COMMUNITY DEVELOPMENT
Planning & Zoning Division

SUBJECT: July 28, 2026 HISTORIC PRESERVATION COMMISSION MEETING

STAUNTON HISTORIC PRESERVATION COMMISSION**June 23, 2026****5:30 p.m.****Council Chambers**

HSF Recommendation

Add glass panels to the top two rows of the existing garage doors. Paint garage doors black

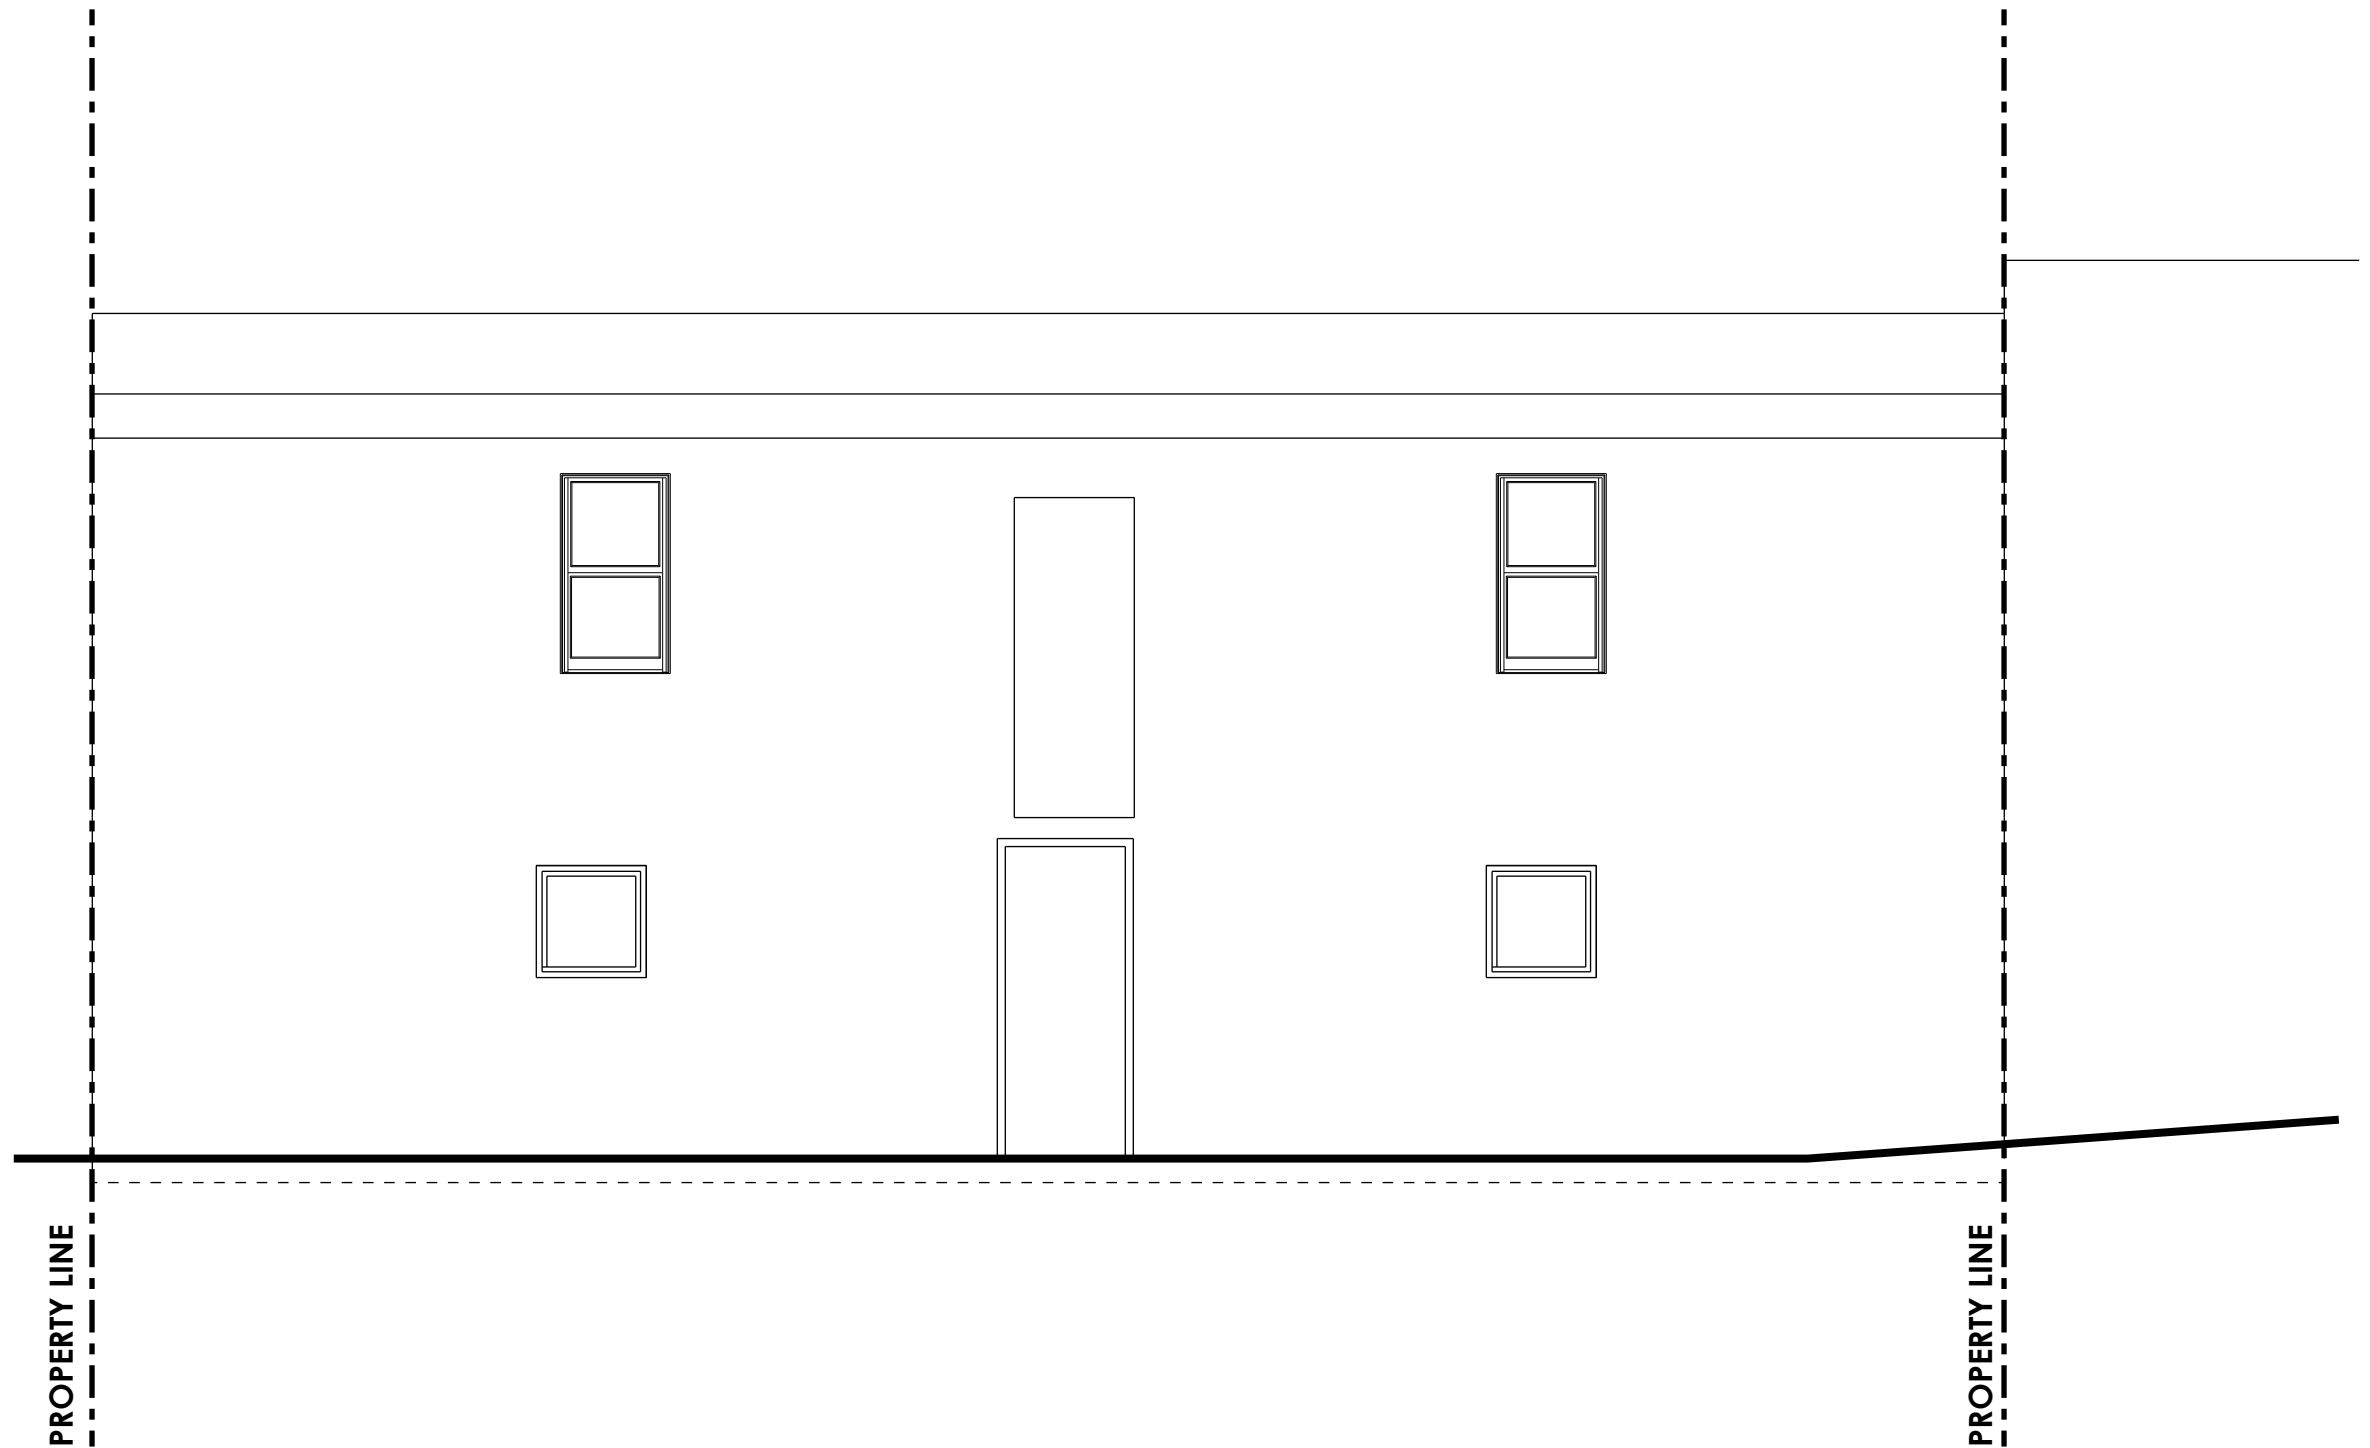
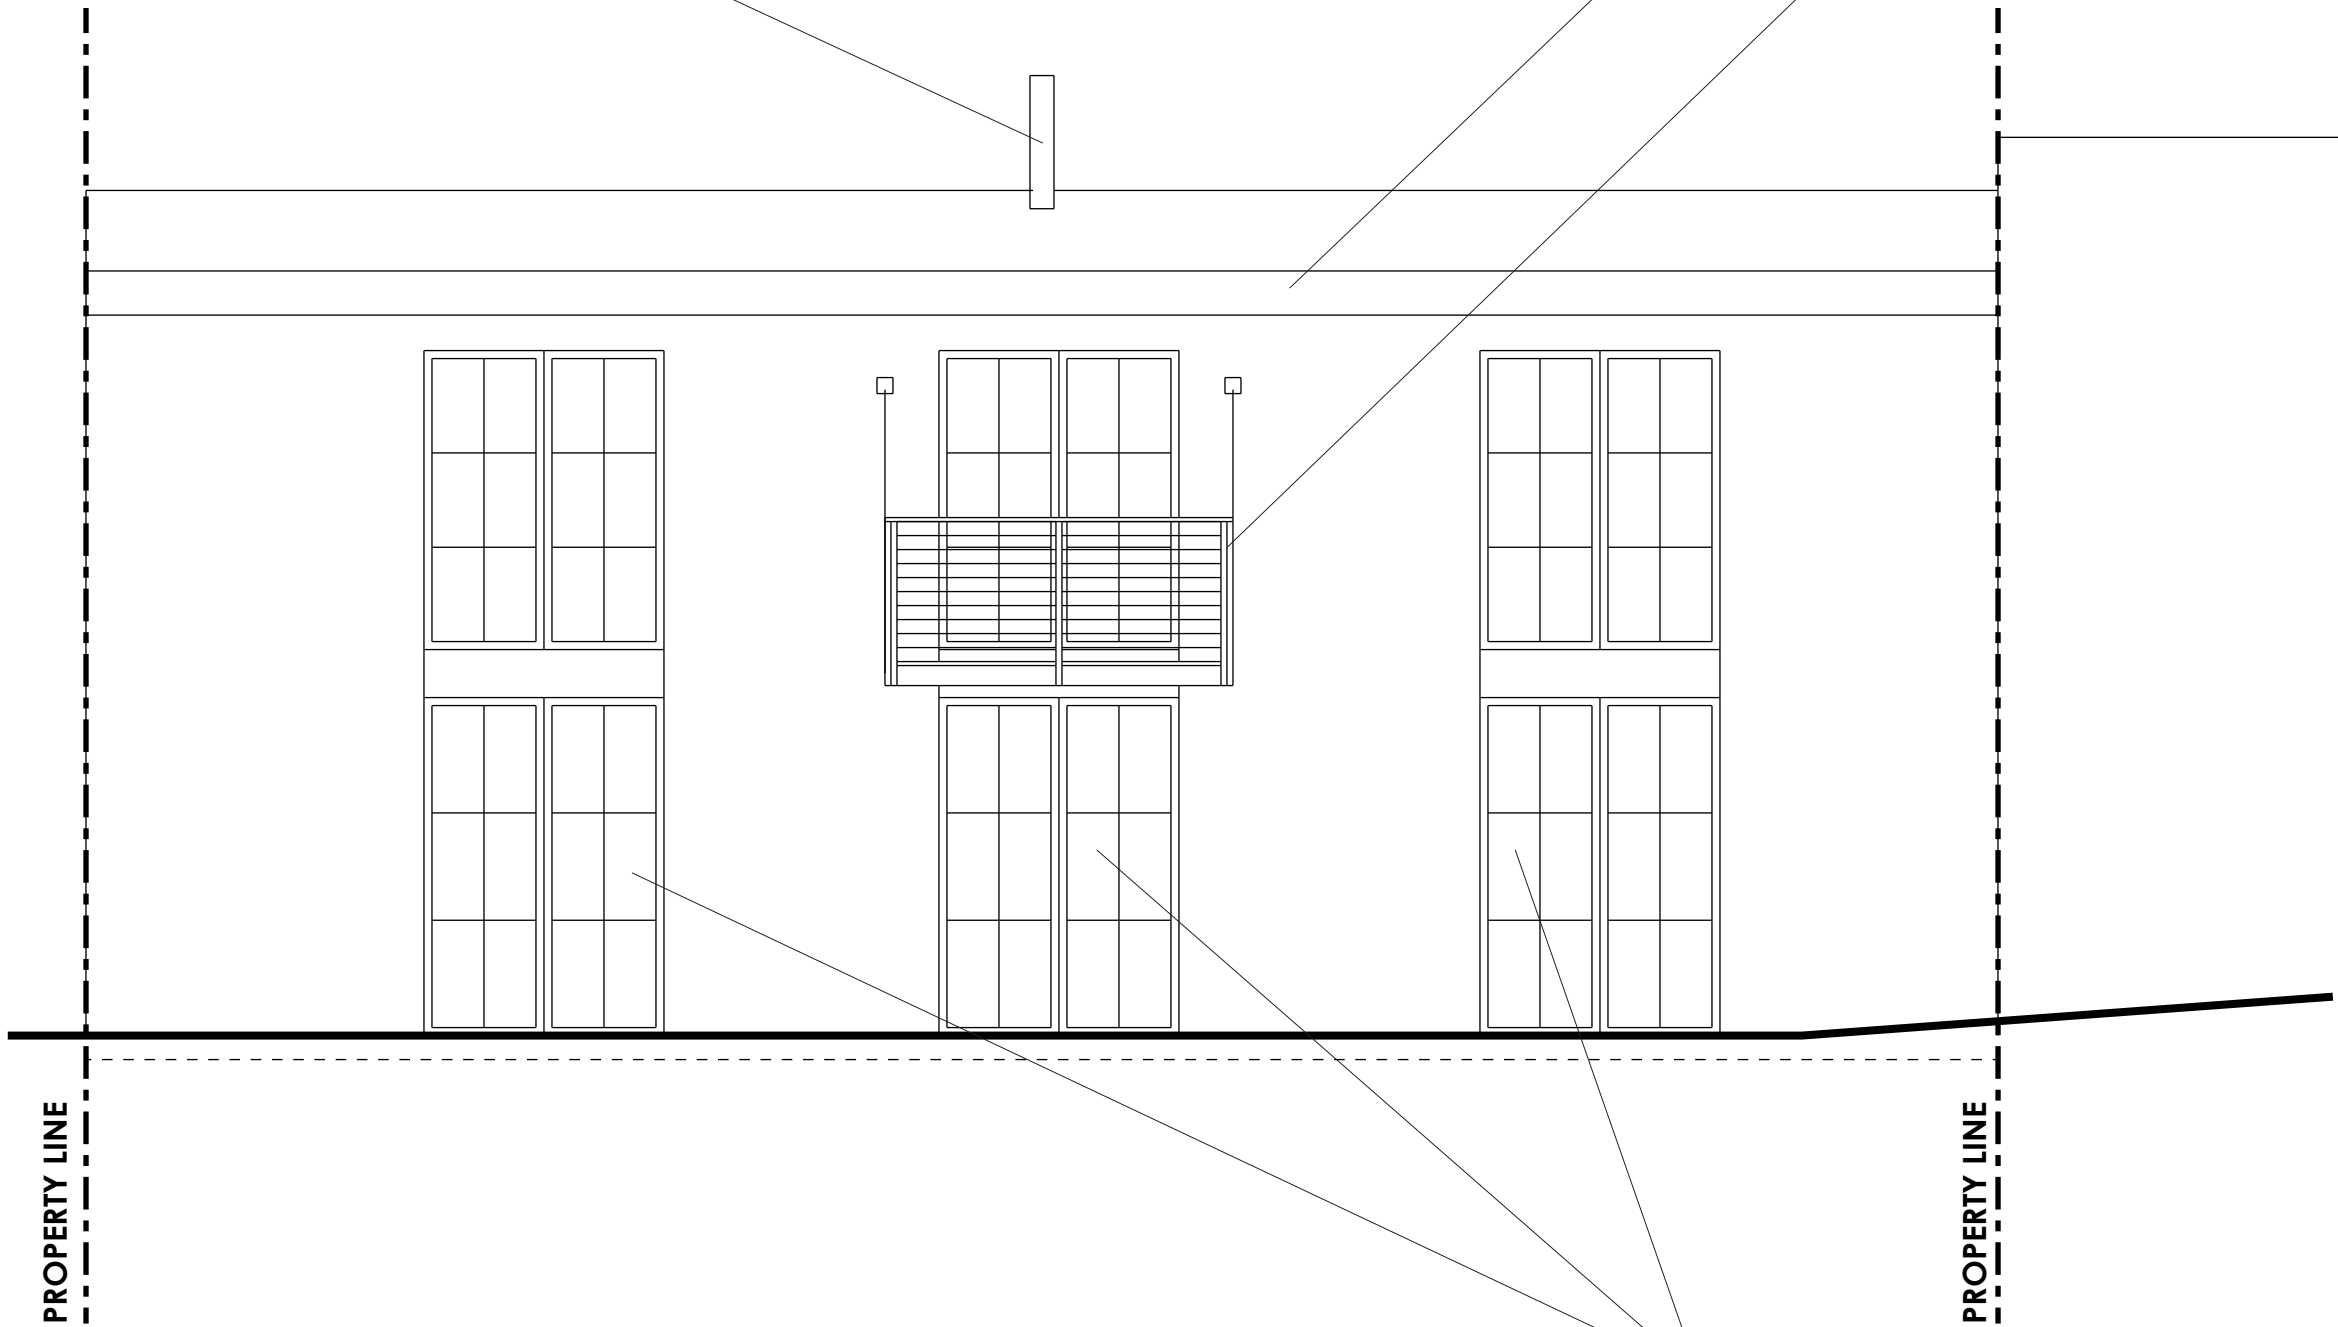
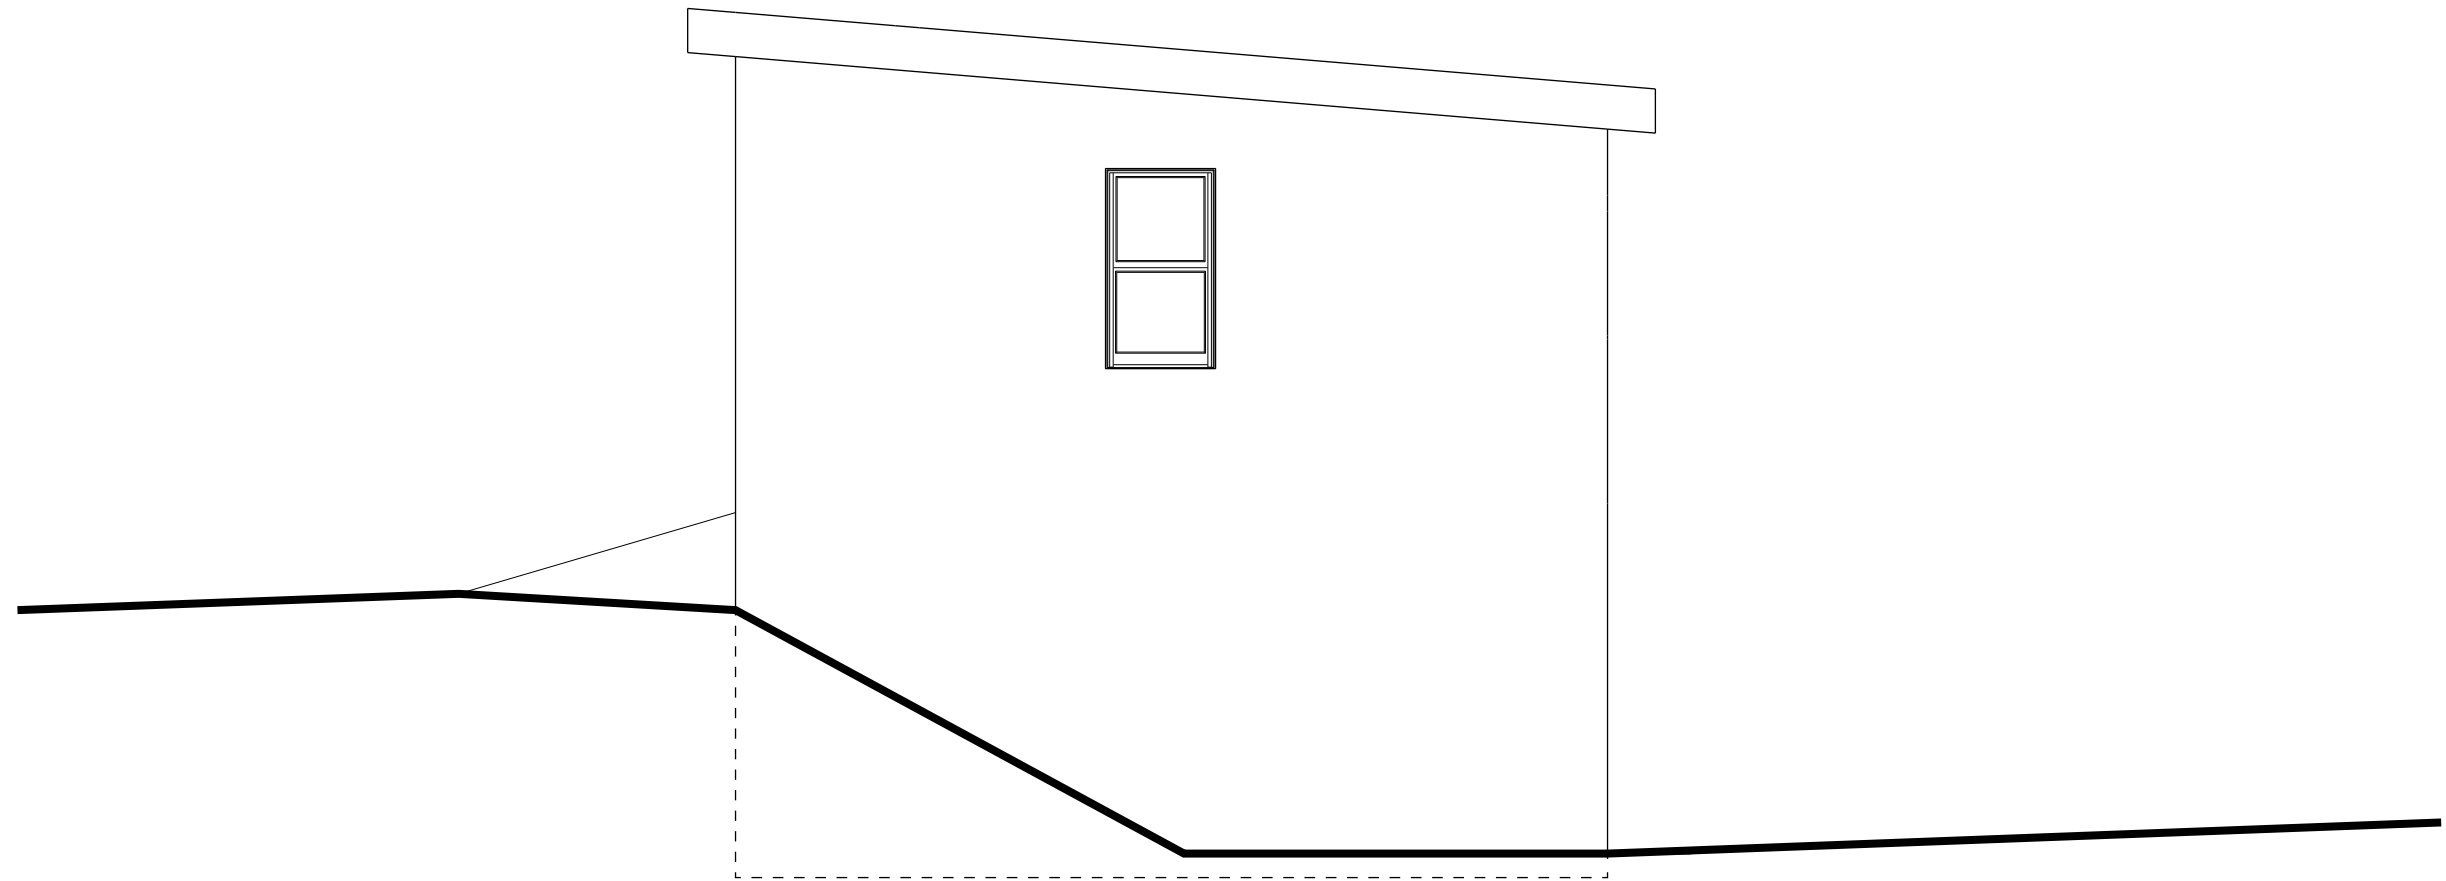
- Add glass panels to the top two rows of the existing garage doors.
- Paint garage doors black
- Add flue pipe for a new interior wood burning stove

- New Openings w/Black Aluminum Clad Windows + Doors
- Add a 3'x7' balcony to the East façade

- Replace the existing window on the South Facade with a new black aluminum clad window

The project involves renovating an existing brick garage. Most of the materials to be used will be existing. The brick will remain as-is. The existing fascia, soffit, garage doors and garage door header will be painted black. Windows and doors will be replaced with new black aluminum clad wood windows. A new steel balcony will added.

The rail and style construction with panels allow a retrofit of the upper panels with glass lights, reflecting the character of early 20th Century garage doors. Therefore, the change alters an existing replacement door by adding compatible glass panels.
